APPENDIX C:
ARBORIST REPORTS

Re: Arborist Report Peer Review 1655 S De Anza: City of Cupertino

Re: Arborist Report for 1655 S De Anza Blvd, Cupertino

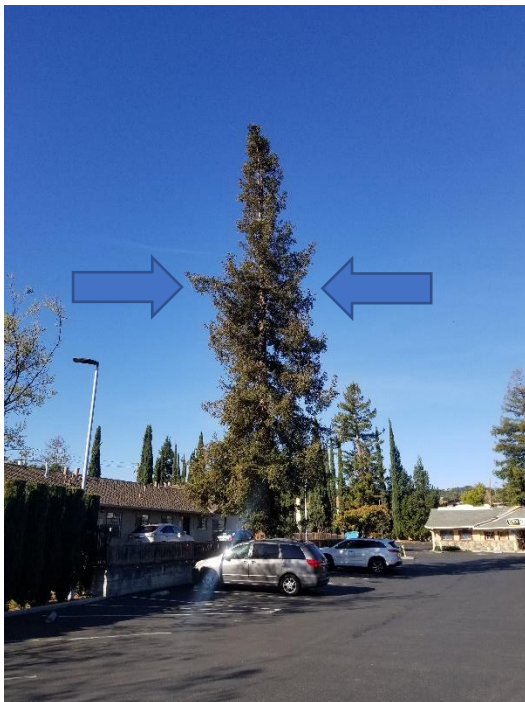
The above photo shows a drought-stressed Coast Redwood (*Sequoia sempervirens*) slated for removal within property lines. The tree is likely suffering from overexposure to the sun and wind and a prolonged California drought.

TREE PROTECTION PLAN
 By: Jennifer Tso
 Certified Arborist #WE-10270A
 Traverso Tree Service, Inc.
 September 3 2020
 (drawn on proposed site plan)

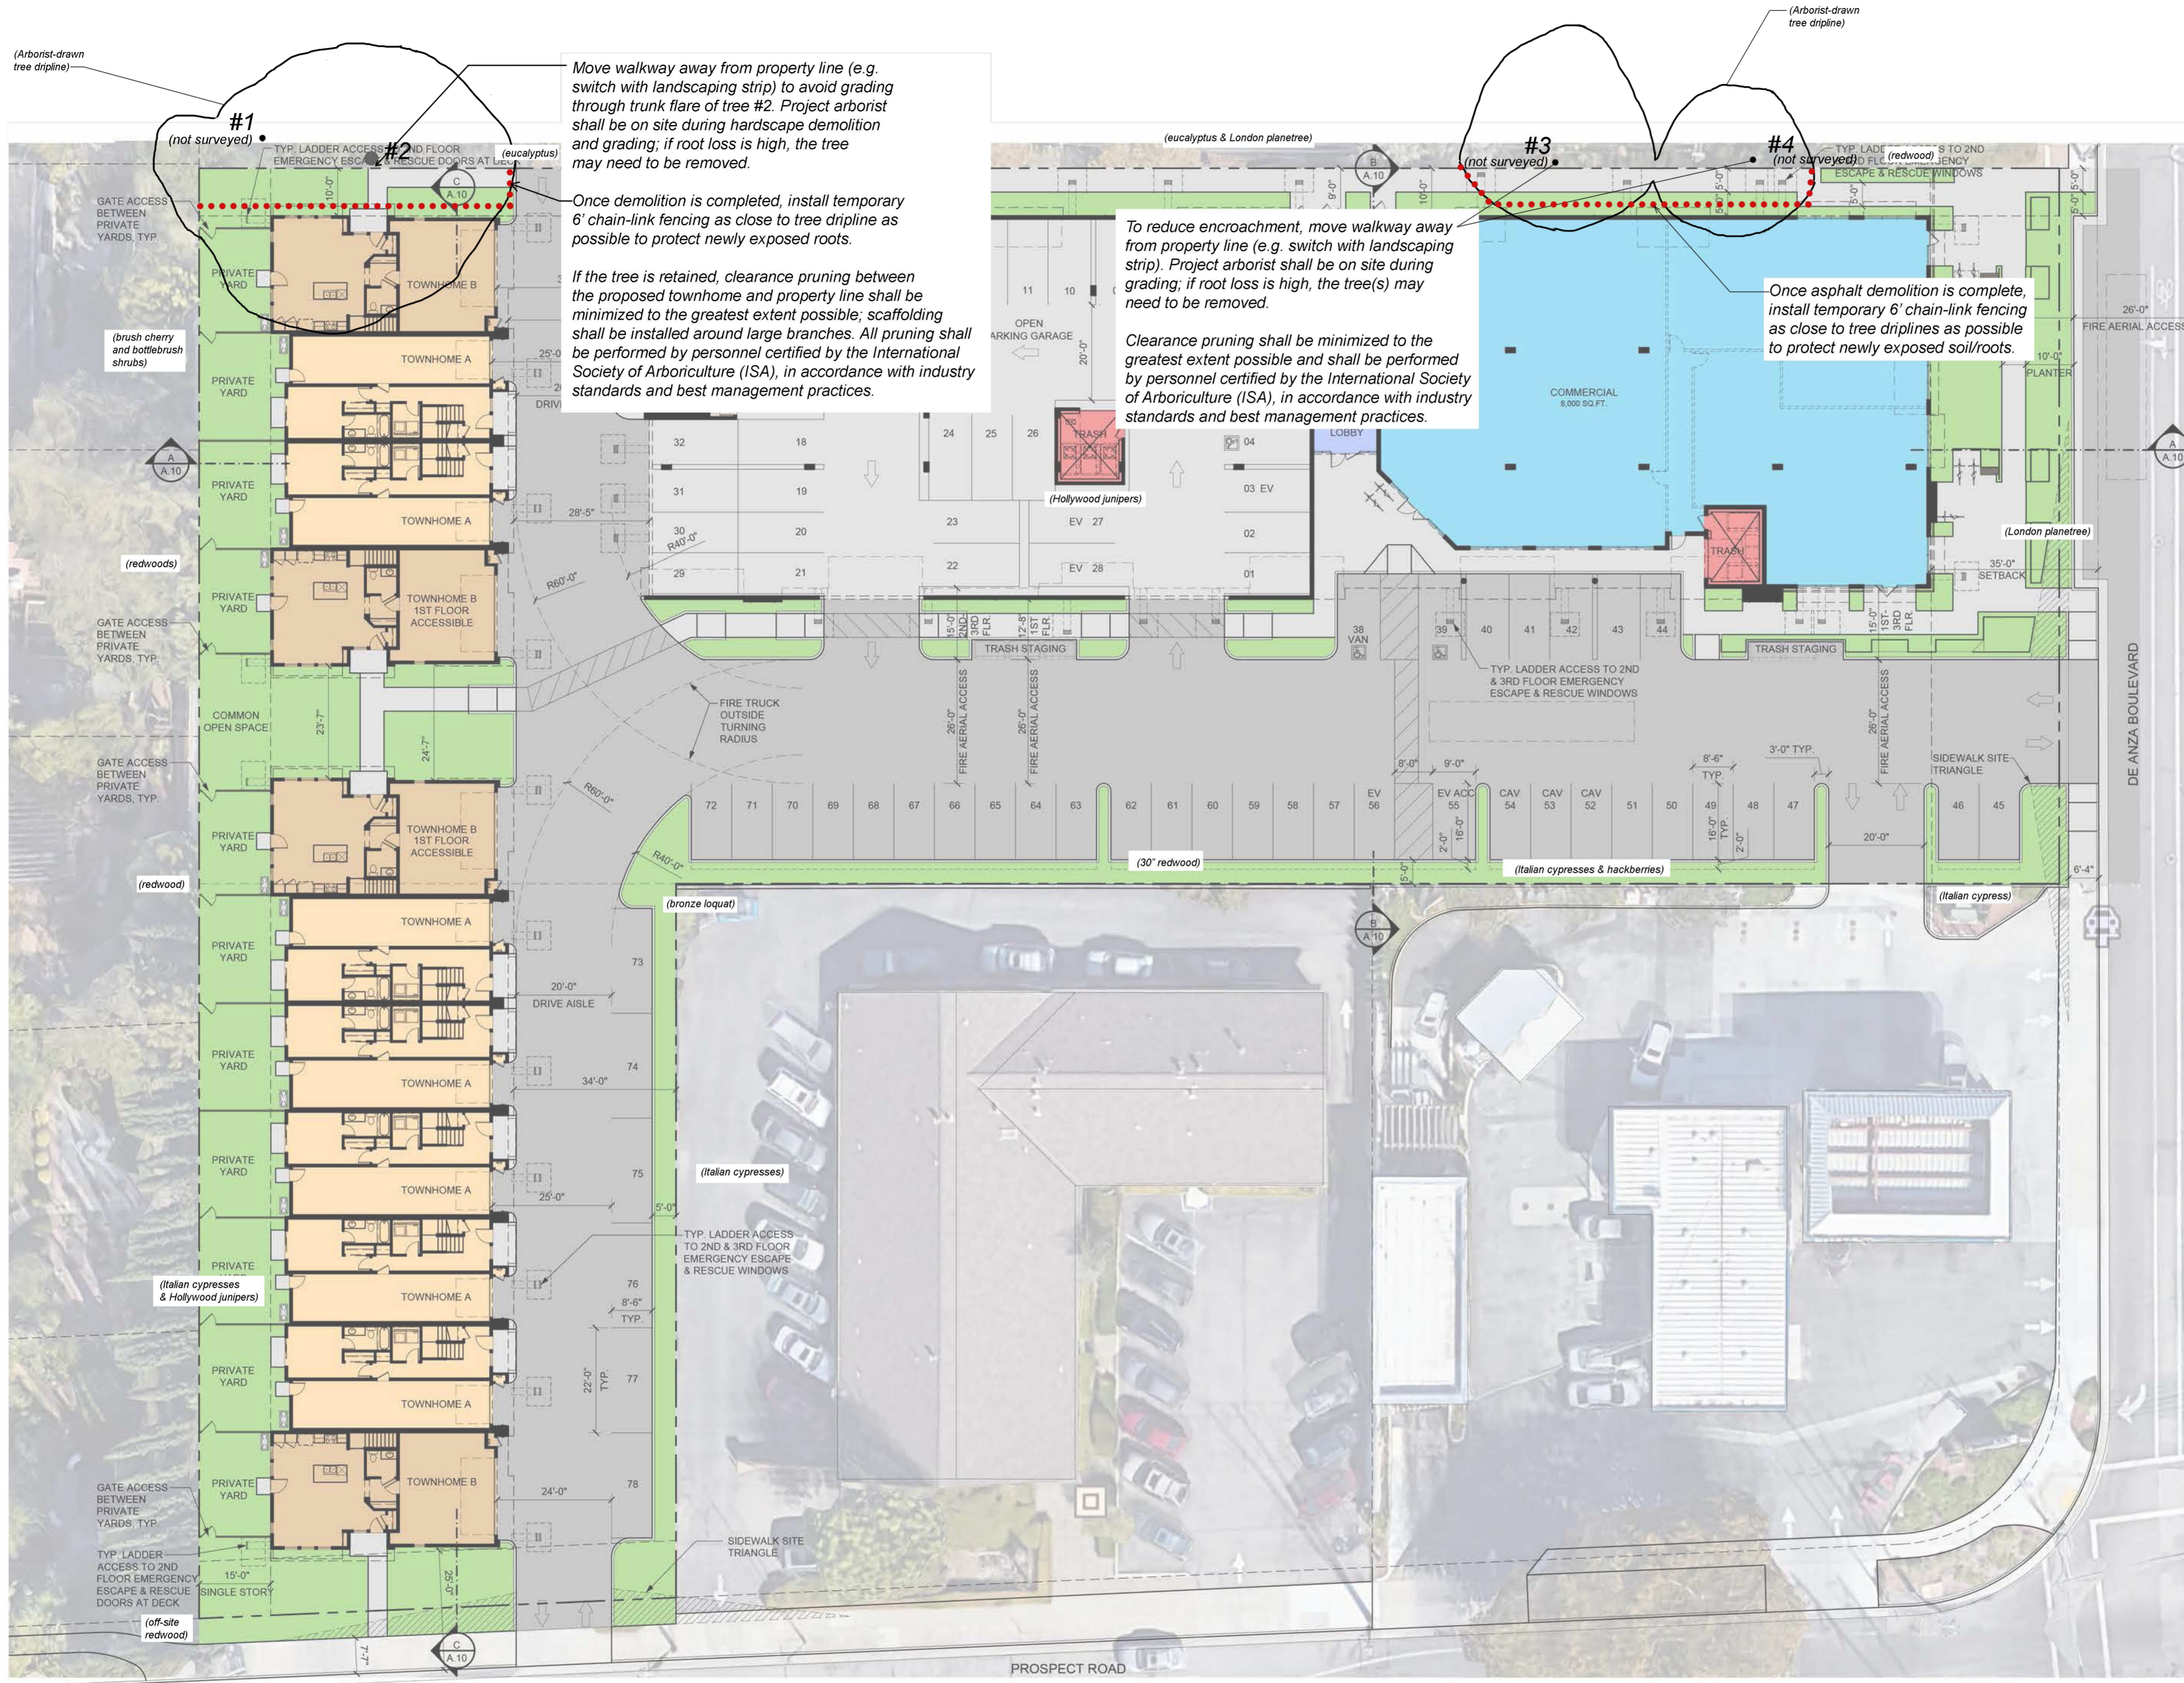
- TREE PROTECTION RECOMMENDATIONS**
- DESIGN PHASE**
- IF FEASIBLE, SWITCH THE LOCATIONS OF THE PROPOSED SIDEWALK AND LANDSCAPE AREA ALONG THE NORTH PROPERTY LINE BY TREES #2-4 TO REDUCE ROOT ENCROACHMENT FROM GRADING. THIS IS ESPECIALLY IMPORTANT FOR TREE #2, WHOSE TRUNK AND ROOTS ARE CLEARLY CAUSING DAMAGE.

- DEMOLITION PHASE**
- THE PROJECT ARBORIST SHALL BE ON-SITE DURING PARKING LOT DEMOLITION WITHIN THE DRIPLINE OF TREE #2. THE ASPHALT NEXT TO THE TRUNK SHALL BE CAREFULLY DEMOLISHED BY HAND TO AVOID DAMAGING THE TRUNK FLARE.

- FOUNDATION, GRADING, AND CONSTRUCTION PHASE**
- THE PROJECT ARBORIST SHALL BE ON-SITE DURING EXCAVATION/GRADING WITHIN THE DRIPLINES OF TREES #2-4. ROOTS $\geq 2'$ SHALL BE CLEANLY PRUNED WITH A HANDSAW OR SAWZALL, IMMEDIATELY COVERED, AND KEPT MOIST TILL BACKFILLED. IF ROOT LOSS IS SIGNIFICANT, THE TREES MAY NEED TO BE REMOVED.
